Date: July 1, 2009
Refer To: EP2009-0311

Subject: Revised Figure 4 and New Figure 5 and Table 8 for the Notice of Self-Implementation of On-Site Cleanup of PCB Remediation Waste at Consolidated Unit 21-003-99 and Solid Waste Management Unit 21-024(c) at Los Alamos National Laboratory (LANL)

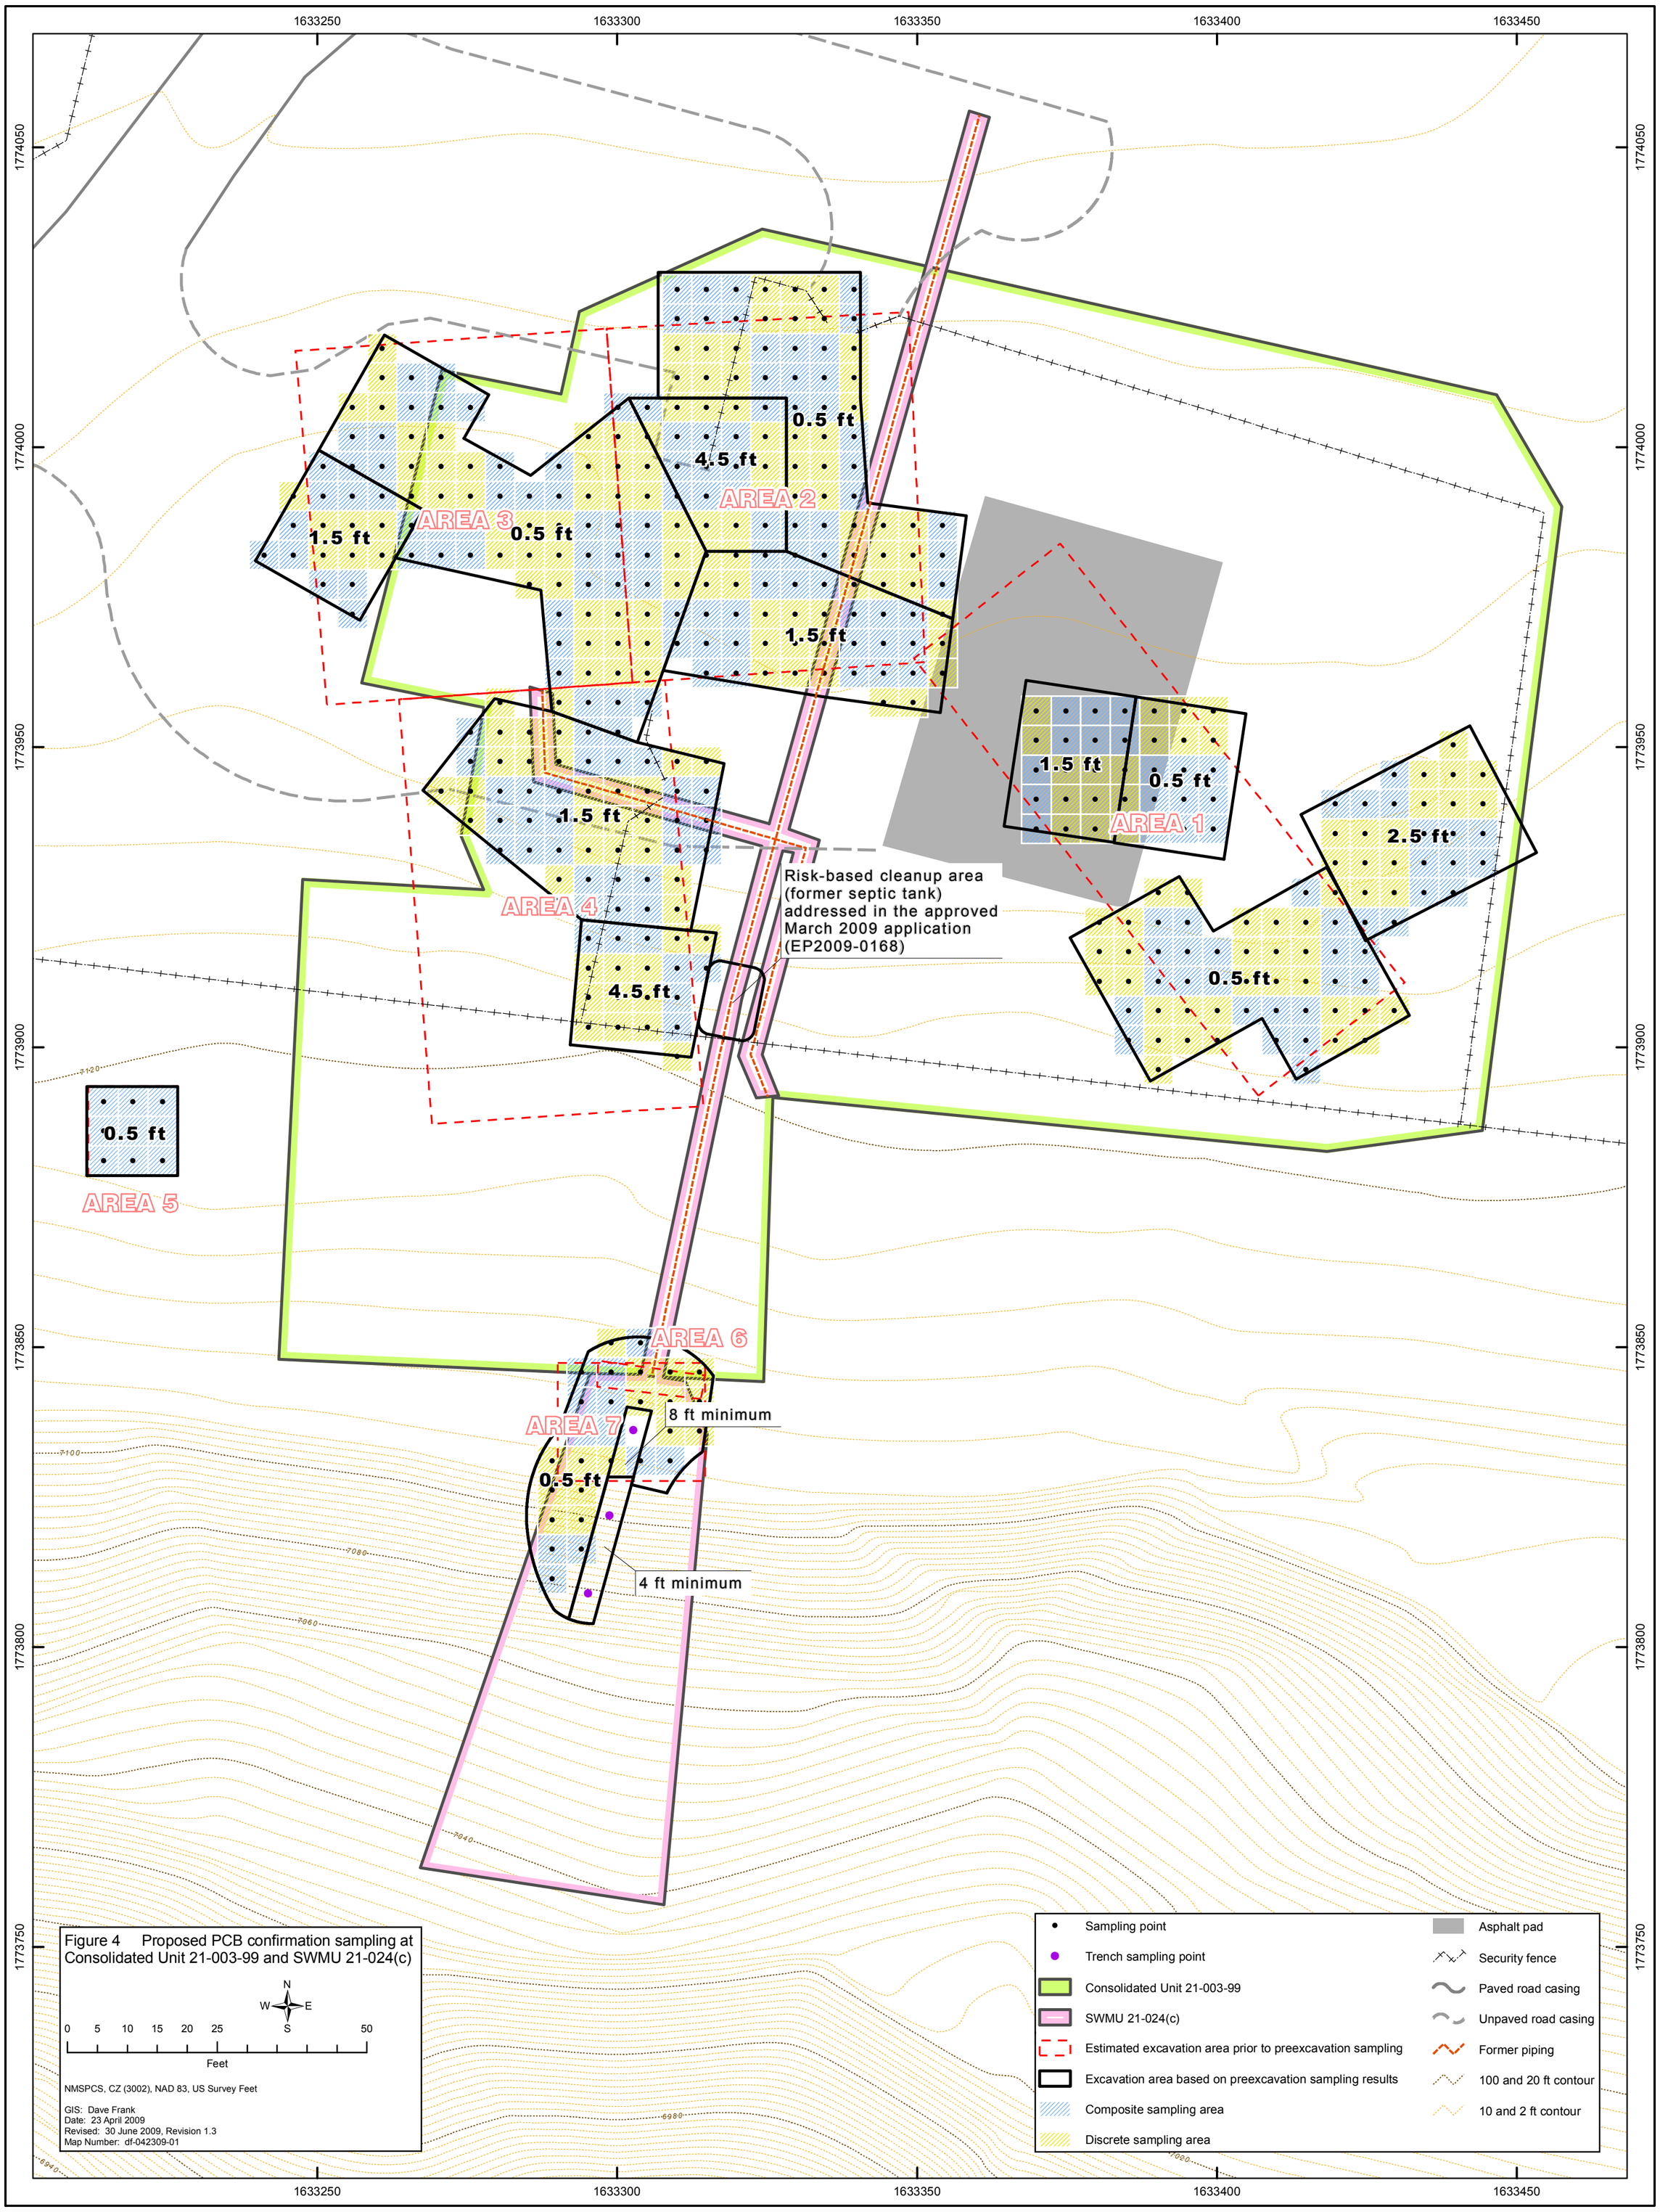
The results of the polychlorinated biphenyl (PCB) preexcavation samples at Consolidated Unit 21-003-99 have been received. In accordance with the schedule section on page 5 of the approved plan, Los Alamos National Laboratory (LANL) has finalized the extent of soil removal and the depths of each of the seven excavation areas at the site. In accordance with the referenced document, LANL is providing notice of changes to the excavation area within 7 days of receiving the preexcavation sampling results. Enclosed please find the following:

- Revised Figure 4 - Proposed PCB Confirmation Sampling Locations
- New Figure 5 - Preexcavation PCB Sampling Results and Revised Excavation Areas
- New Table 8 - Preexcavation PCB Sampling Results
